## Planning Commission Staff Report

Subject:182 Daly AvenueProject #:PL-16-03084Author:Hannah M. Tyler, PlannerDate:October 24, 2018Type of Item:Administrative – Steep Slope Conditional Use Permit

Subject:182 Daly Avenue Duplex Dwelling188Project #:PL-17-03708PLANNING DEFAuthor:Hannah M. TylerPLANNING DEFDate:October 24, 2018Type of Item:Administrative – Duplex Dwelling Conditional Use Permit

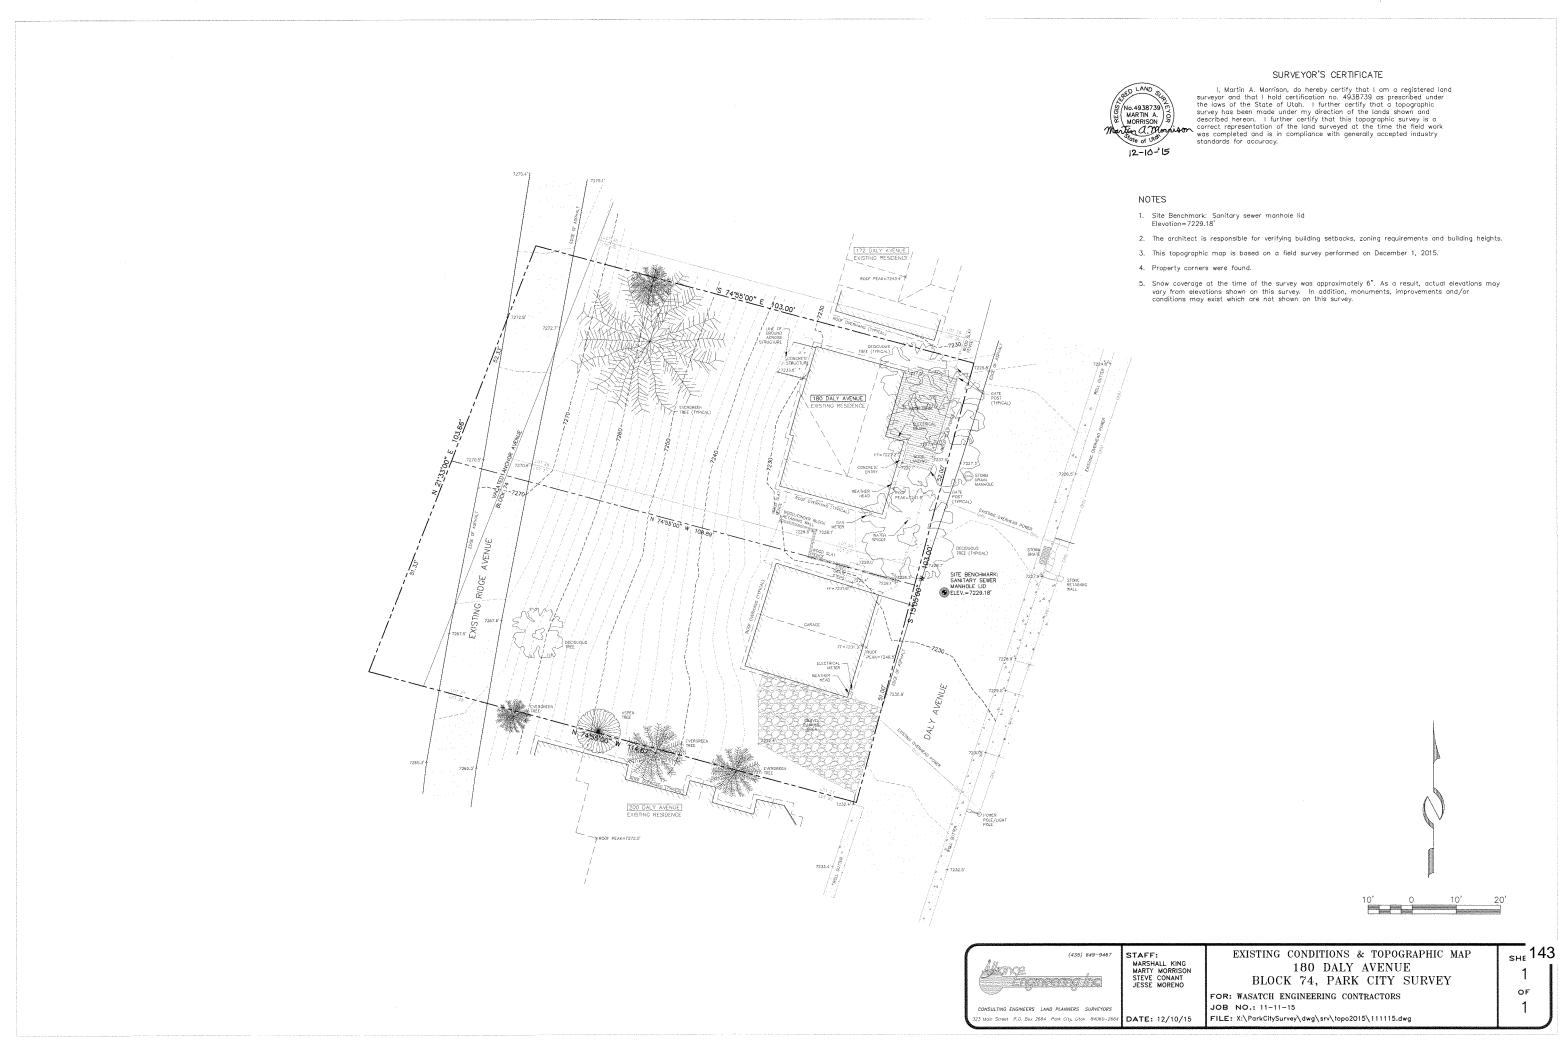
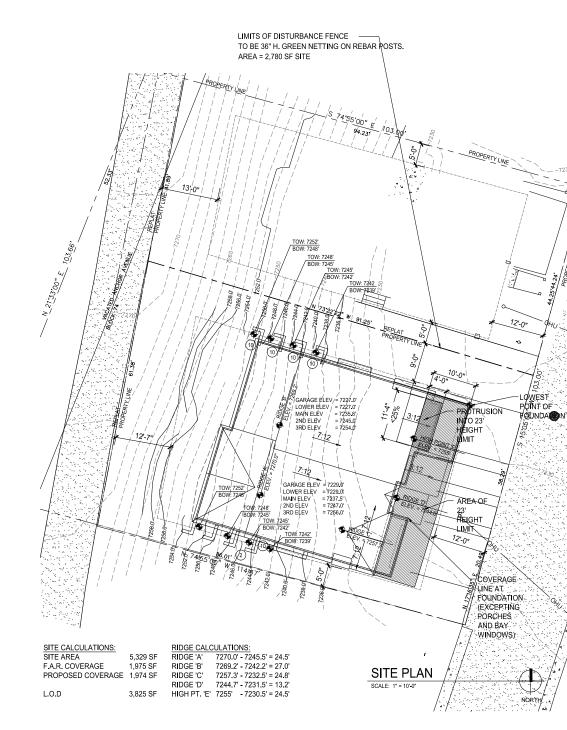
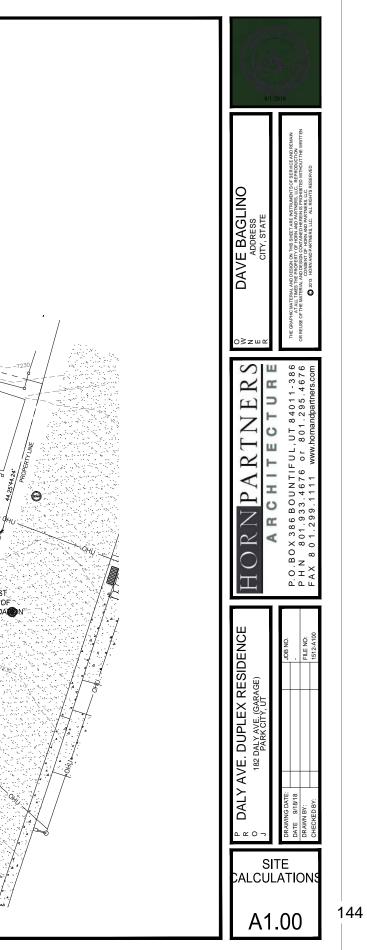
This project has been reviewed by the applicable utility companies and internal departments. No concerns were brought up by those entities during their review. The applicant has provided information regarding the proposed utility plan on the Site Plan (Sheet A1.0).

- 17. There are no unmitigated impacts to LMC 15-1-10(E)(3) Utility capacity, as this project has been reviewed by the applicable utility companies and internal departments. No concerns were brought up by those entities during their review. The applicant has provided information regarding the proposed utility plan on the Site Plan (Sheet A1.0).
